* NOTE: THIS SCHEMATIC IS FOR "G" REV AND UP 80296-01 RF BD ONLY. FOR PARTS PLACEMENT SEE XD529-02

This information is confidential and proprietary to Motorola Corporation of Indiana and shall not be divulged or used by the Government of Motorola Corporation of Indiana without written permission.			
Ref. Model	G02-65		
Apprv. Basic	DO NOT SCALE DIMS.		
Originator	Date	Mod. Eng.	Date
Des. Eng.	Date	Prod. Eng.	Date
Tolerances unless otherwise specified			
2 Place dec. ± 0.05 3 Place dec. ± 0.008			
Fractions ± 1/64 Angles ± 1/8°			
Title	175 MHz R.F. BD		
Part No.	XD445-02		
Rev.	Y

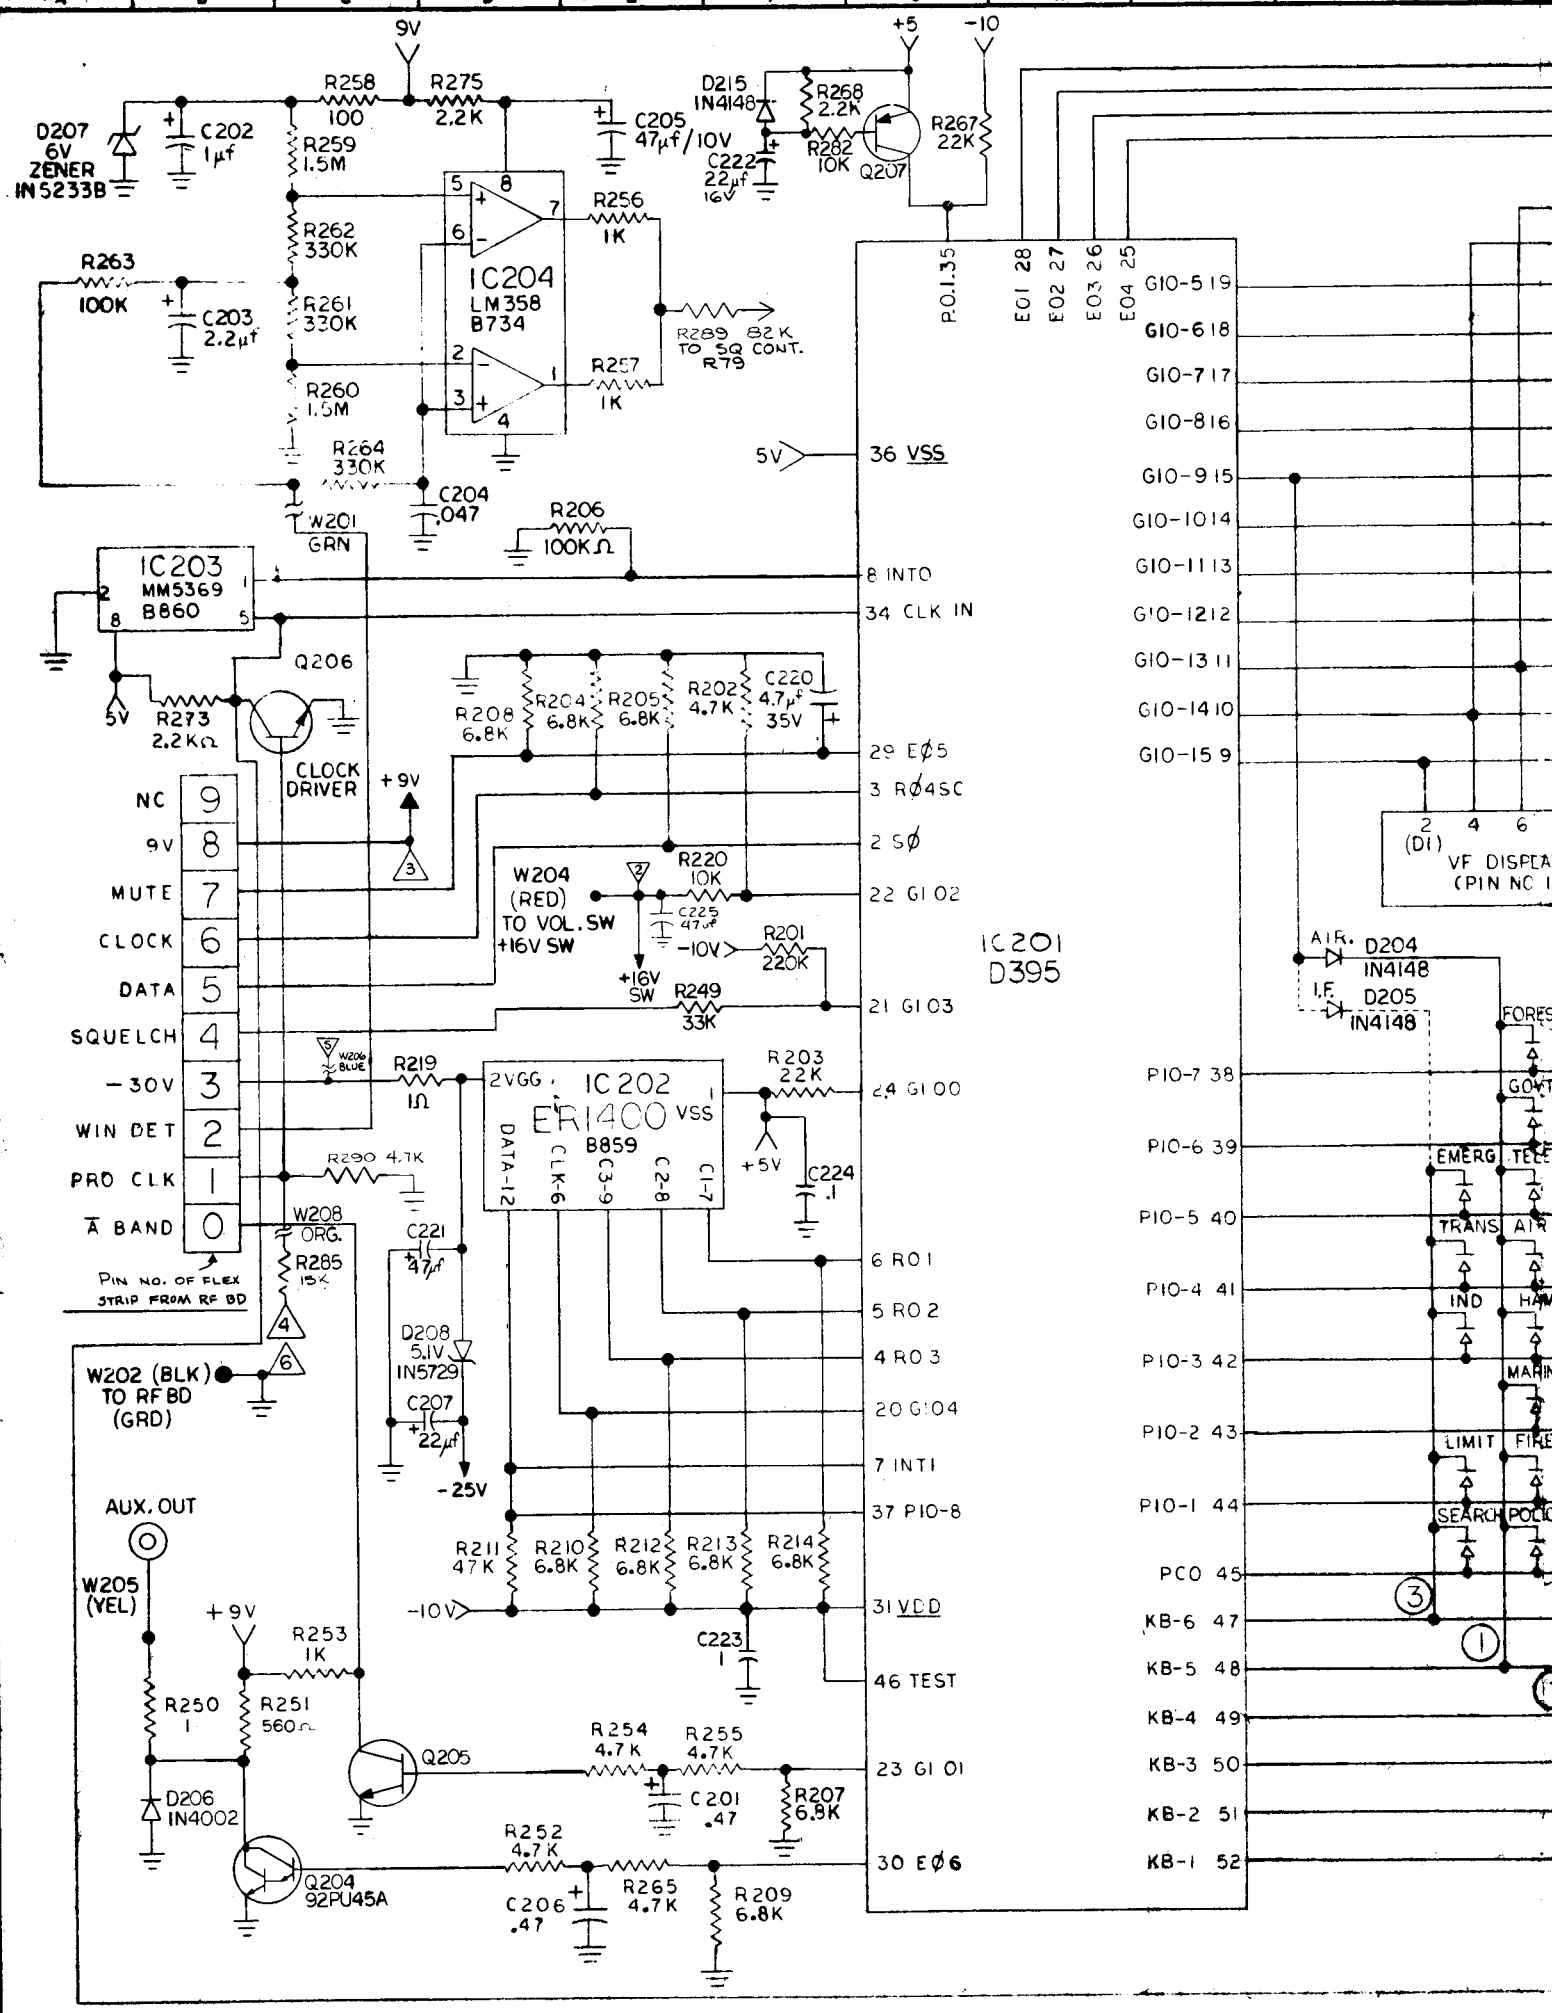
Rev.	EN	Description & Location	Int.	Ass.
A	389	RELEASED		
B	24	C86 WAS 470F/16V R76 WAS 10.5K R76 WAS R22 ADDED C113 470M/16V	3	3
C	345	CHANGED R33 FROM 15K TO 10K	2	3
D	78	ADDED R136 8.2K & Q19 ZONE 5-F	5	3
E	350	CHANGED C103, C106, C108 & C107 FROM 4.7U/15V TO 4.7U/10V	5	3
G	450	ADDED C114 ZONE 11-M	5	3
H	451	CHANGED C119 65K C111 FROM TANT TO SUBV. 212 54 7A	5	3
I	409	R69 WAS 100Ω (R1000 & R1004) R101 WAS 12K M13 (R10023) 5.5K (R100562) R108 WAS 18K M9 (R100183) 15 8.2K (R10087) C90 WAS 22M (M9) (C105 & R2A) 15 .47 (C50 & 7A)	1	11-17-80
J	437	ZONE M-3 C50 RES. .47 ZONE N-100 RES. 8.2K R107 WAS 5.6K	4	11-17-80
K	450	ZONE M-3 C50 RES. .47 ZONE N-100 RES. 8.2K R107 WAS 5.6K	4	11-17-80
L	451	ZONE M-3 C50 RES. .47 ZONE N-100 RES. 8.2K R107 WAS 5.6K	4	11-17-80
M	451	ZONE M-3 C50 RES. .47 ZONE N-100 RES. 8.2K R107 WAS 5.6K	4	11-17-80
N	451	ZONE M-3 C50 RES. .47 ZONE N-100 RES. 8.2K R107 WAS 5.6K	4	11-17-80

P	451	ZONE M-3 C50 RES. .47 ZONE N-100 RES. 8.2K R107 WAS 5.6K	4	11-17-80
Q	451	ZONE M-3 C50 RES. .47 ZONE N-100 RES. 8.2K R107 WAS 5.6K	4	11-17-80
R	451	ZONE M-3 C50 RES. .47 ZONE N-100 RES. 8.2K R107 WAS 5.6K	4	11-17-80
S	451	ZONE M-3 C50 RES. .47 ZONE N-100 RES. 8.2K R107 WAS 5.6K	4	11-17-80
T	451	ZONE M-3 C50 RES. .47 ZONE N-100 RES. 8.2K R107 WAS 5.6K	4	11-17-80
U	451	ZONE M-3 C50 RES. .47 ZONE N-100 RES. 8.2K R107 WAS 5.6K	4	11-17-80
V	451	ZONE M-3 C50 RES. .47 ZONE N-100 RES. 8.2K R107 WAS 5.6K	4	11-17-80
W	451	ZONE M-3 C50 RES. .47 ZONE N-100 RES. 8.2K R107 WAS 5.6K	4	11-17-80
X	451	ZONE M-3 C50 RES. .47 ZONE N-100 RES. 8.2K R107 WAS 5.6K	4	11-17-80
Y	451	ZONE M-3 C50 RES. .47 ZONE N-100 RES. 8.2K R107 WAS 5.6K	4	11-17-80
Z	451	ZONE M-3 C50 RES. .47 ZONE N-100 RES. 8.2K R107 WAS 5.6K	4	11-17-80

XP 280-028

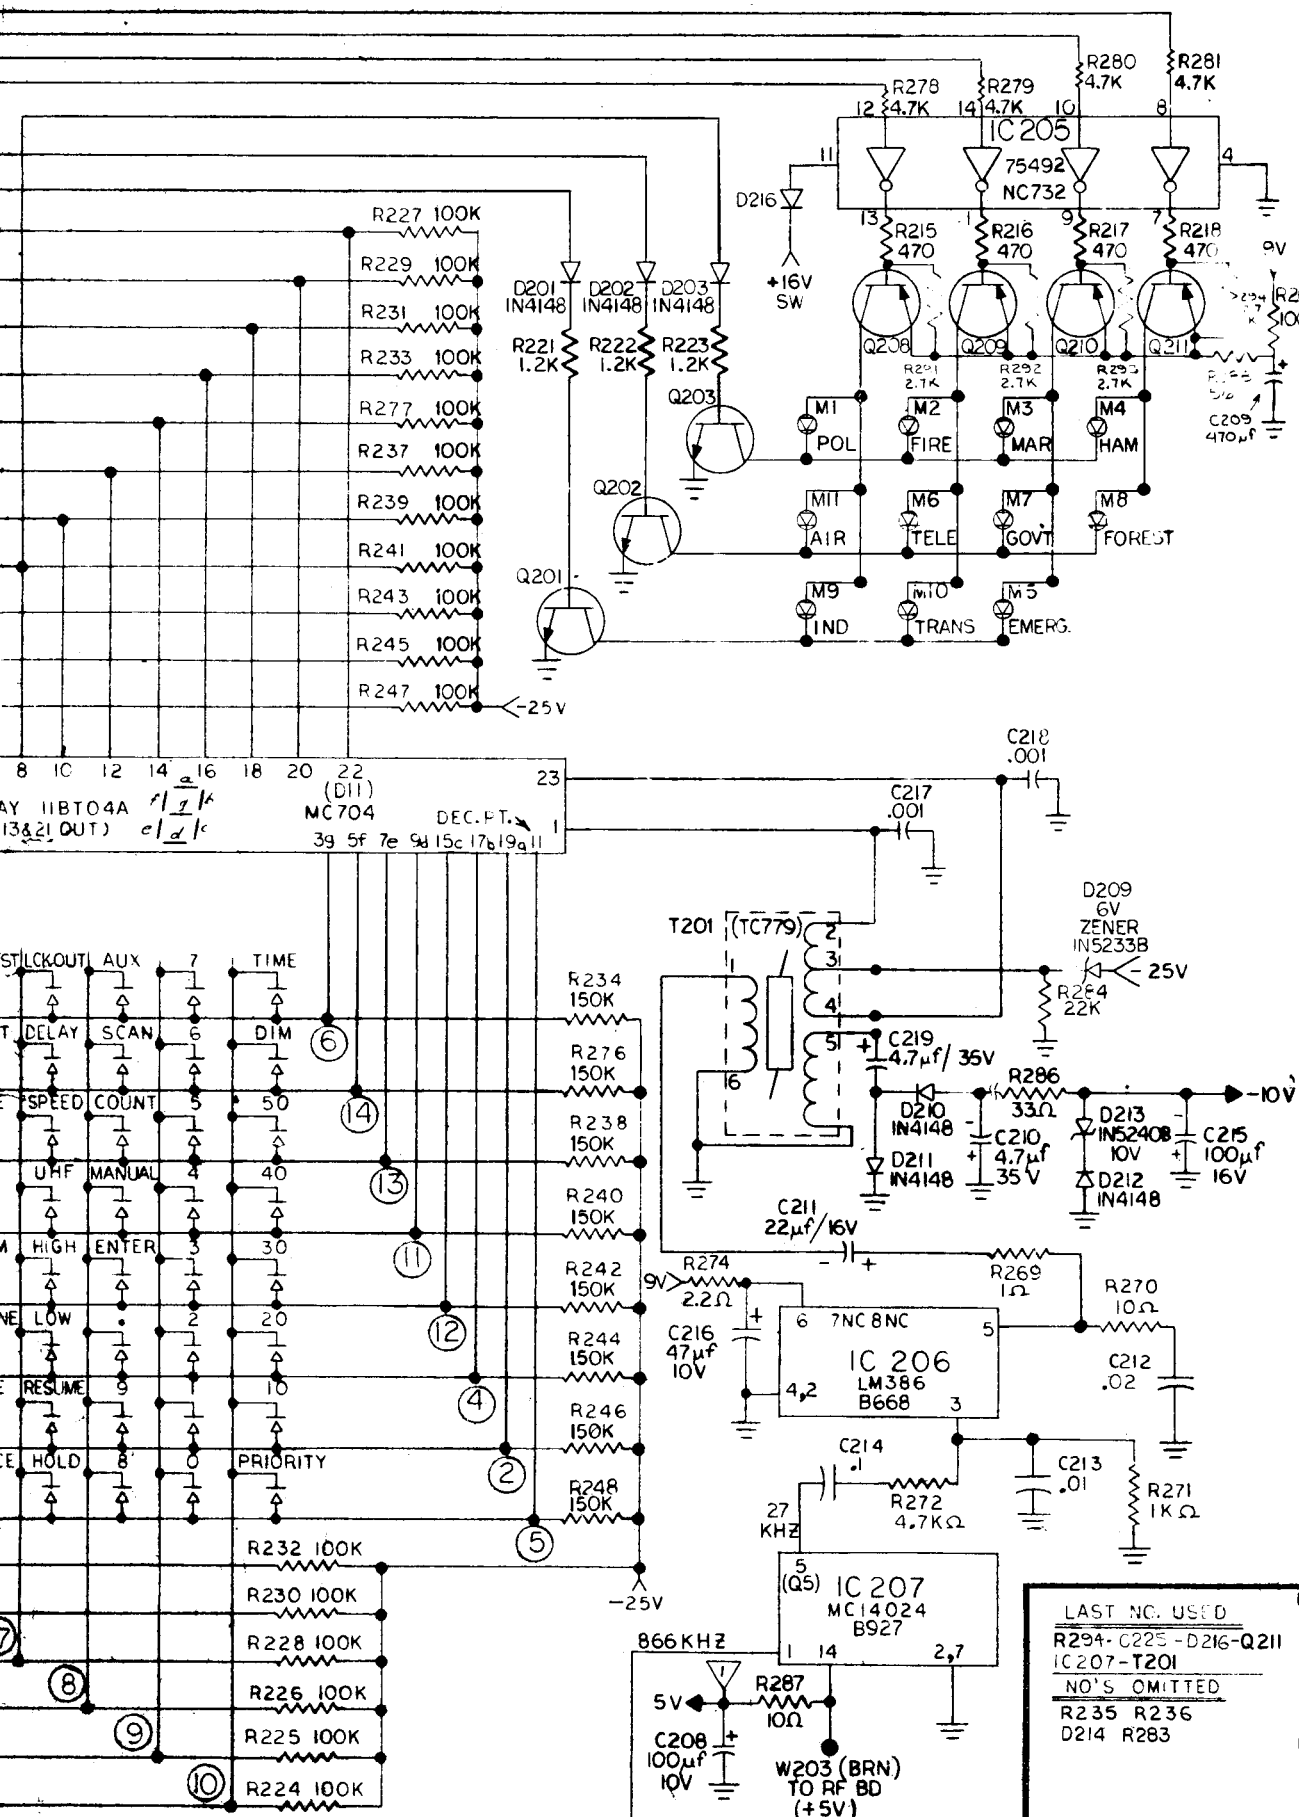
Rev.	EN	Description & Location
A	50	RELEASE BOARD
B	4	ADDED C215 ZONE E-7
C	4	ADDED R290 ZONE 9-C
D	4	ADDED R291 R292 R293, R294 ALL 2.7K ZONE 3T R294 3V
E	4	CHANGED R290 FROM 2.7K TO 4.7K
F	4	CHANGED R286 FROM 10K TO 15K PINE C 9
